CITY OF JOLIET

ADDENDUM NO. 1

TO: **2024 SIDEWALK/ CURB REPLACEMENT PROJECT- EAST JOLIET**

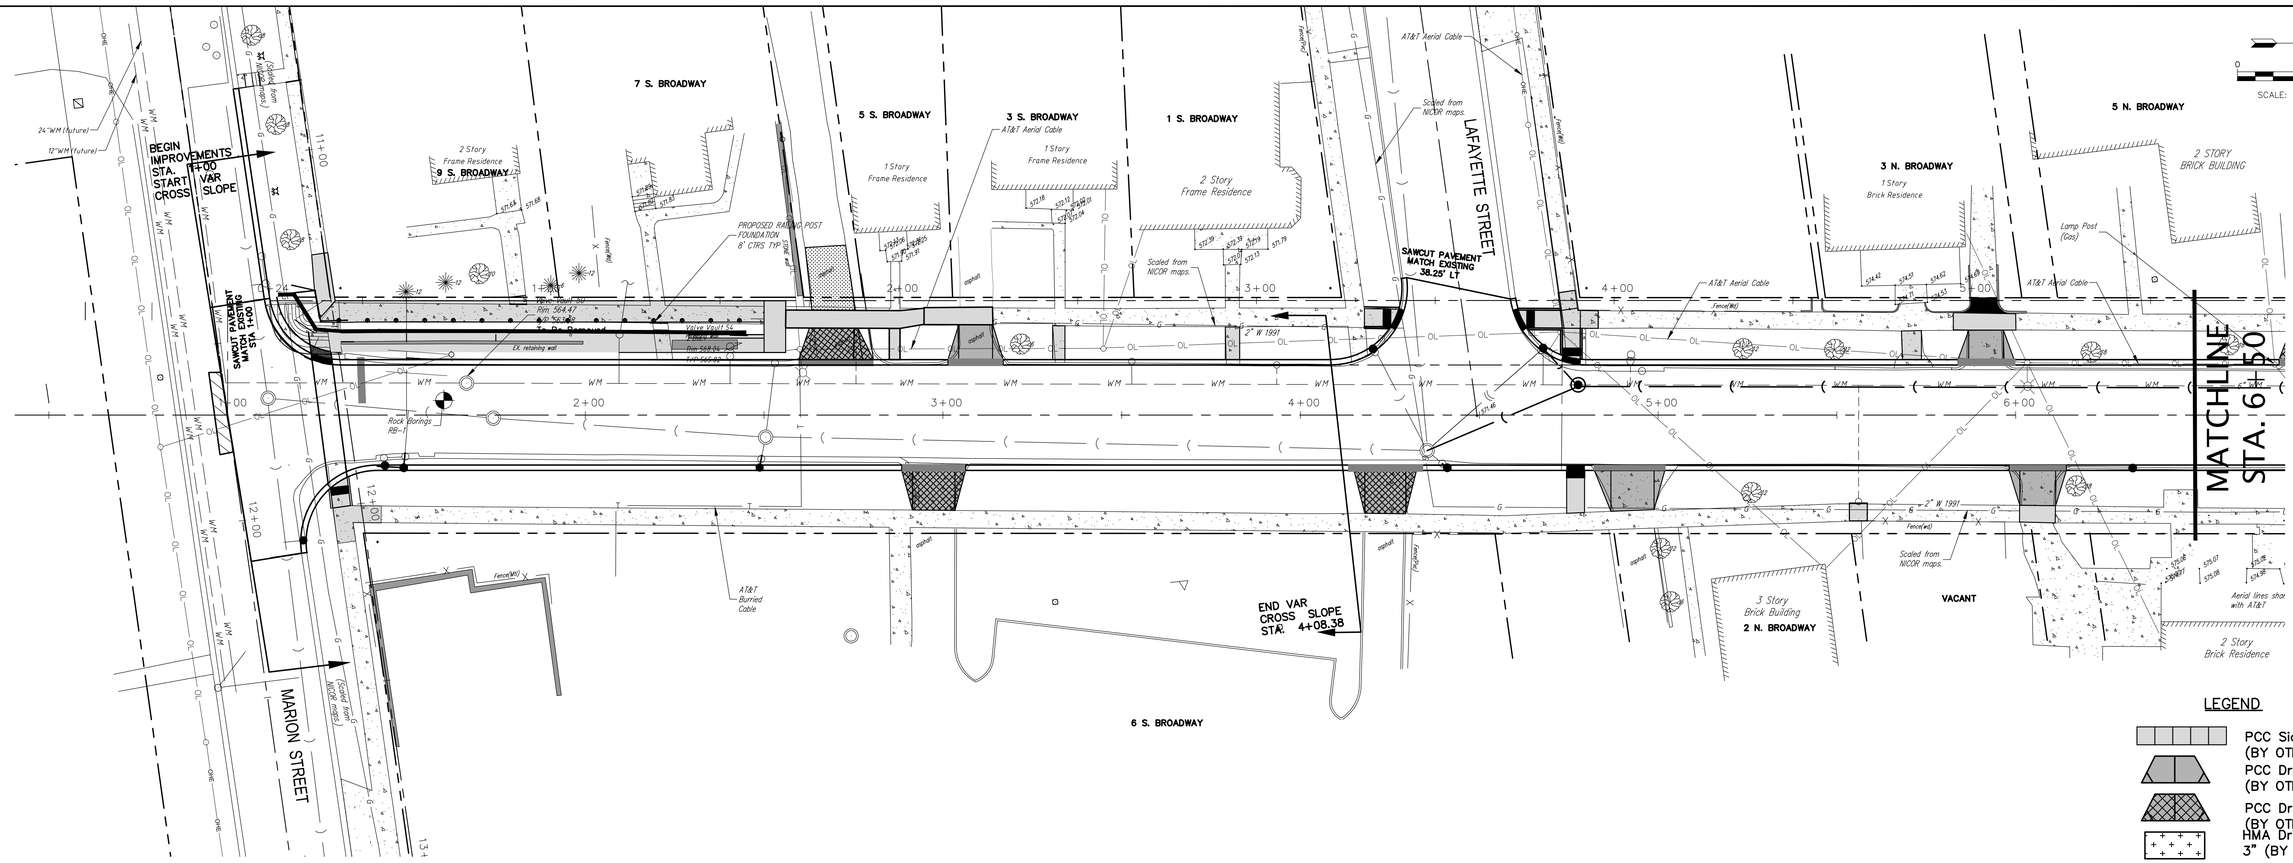
1) Attached is detail for handrail to be installed at parking lot across street from 706 N Broadway St. at location shown on the attached drawing.
2) All material, equipment and labor to excavate and place concrete foundation shall be included in cost of item for Handrail and Railing.

STEEL HANDRAIL (ADA) DETAIL– PER IDOT SPEC

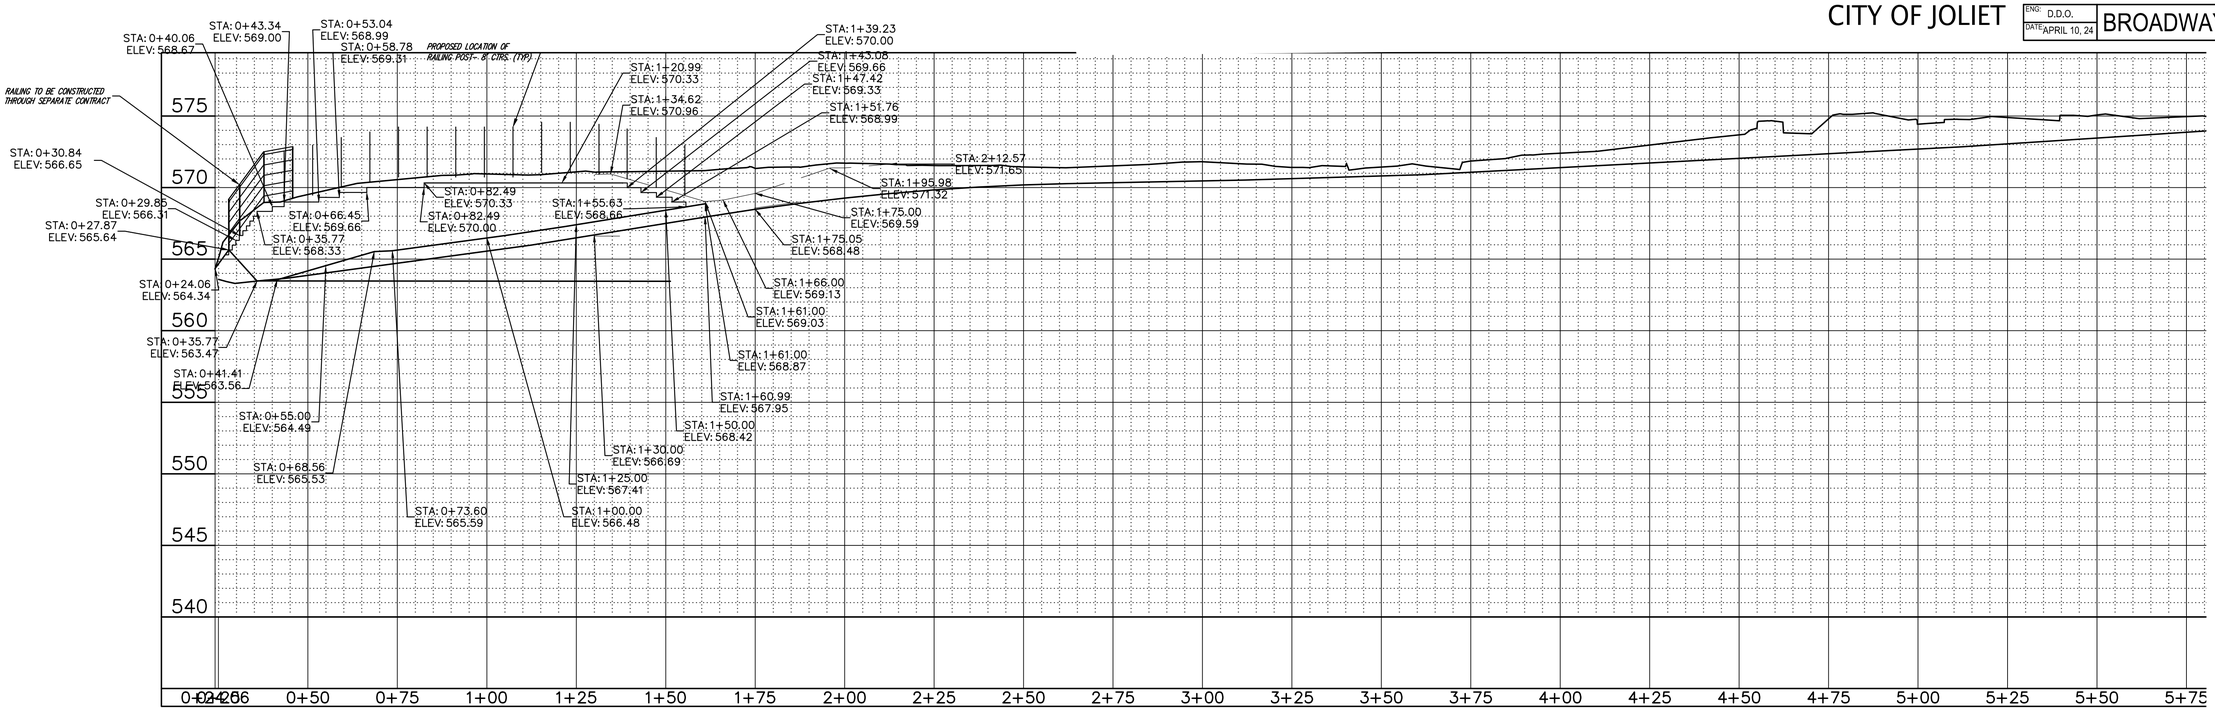
3) Top of railing foundation concrete shall be finished to match existing sidewalk.
4) Foundations for railing above retaining wall are to be excavated with hand held equipment. No heavy equipment will be allowed on top of retaining wall. Attached is drawing showing retaining wall heights with proposed foundation locations. Only railing w/ foundation will be installed with this project. Foundation form will be pre-installed and filled with sand by separate contract.
